Southern Water Winchester City Council Local Plan Reg 19 Consultation – Supplementary Response

Further to our consultation response provided 11 October 2024 and the duty to co-operate meeting held 29 October 2024, I write to request some modifications to the criterion that we have proposed.

Policy SH3 - Whiteley Green - SWS Infrastructure

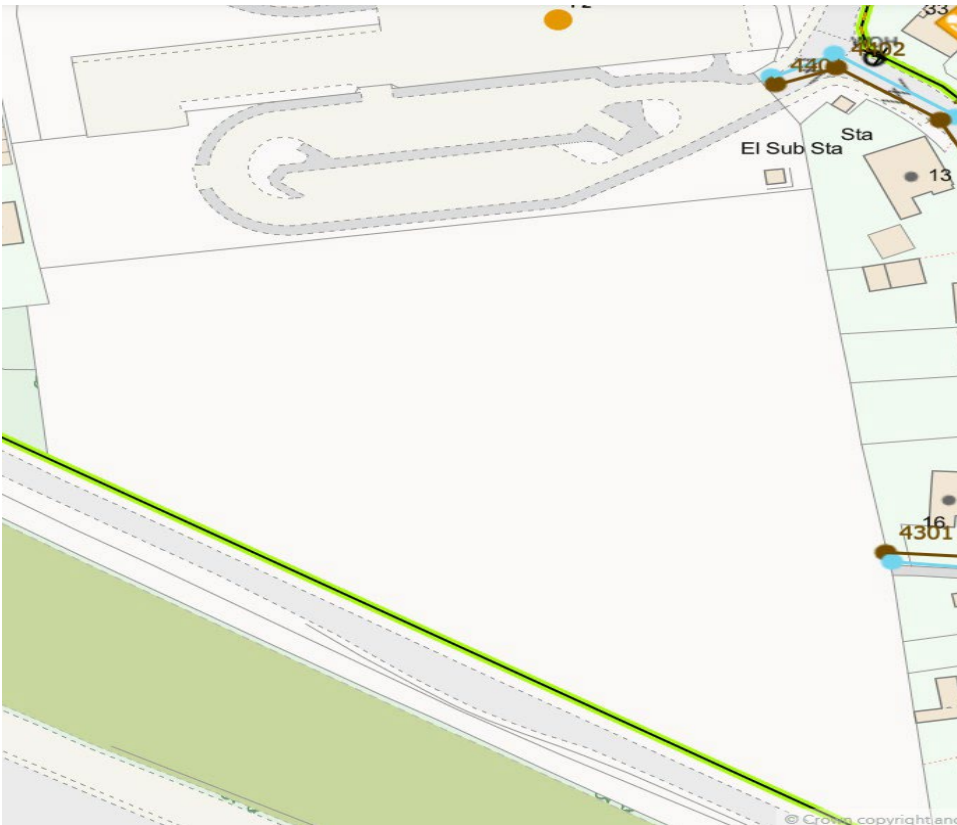
Thank you for sharing the e-mail confirmation provided by Hampshire County Council in relation to the site boundary and Southern Water infrastructure (excerpt of the e-mail below).

"I have attached a snip of our red/blue line plans for the site. As you can see the development proposals are outside the public highway, so Winchester can remove the easement requirement from the draft policy requirements."

Southern Water assets in Bader Way and Cobham Grove

On the basis of the above we recommend the following modifications to the wording for 13.31 of Policy SH3.

There are foul and surface water sewers ~~running across the site which would require an easement of 6m to be kept clear of all buildings and tree planting~~ located in Bader Way and Cobham Grove, with manholes in close proximity to the site boundary. It is important that the exact location of this infrastructure in relation to the site is established prior to the commencement of any construction, in liaison with Southern Water.
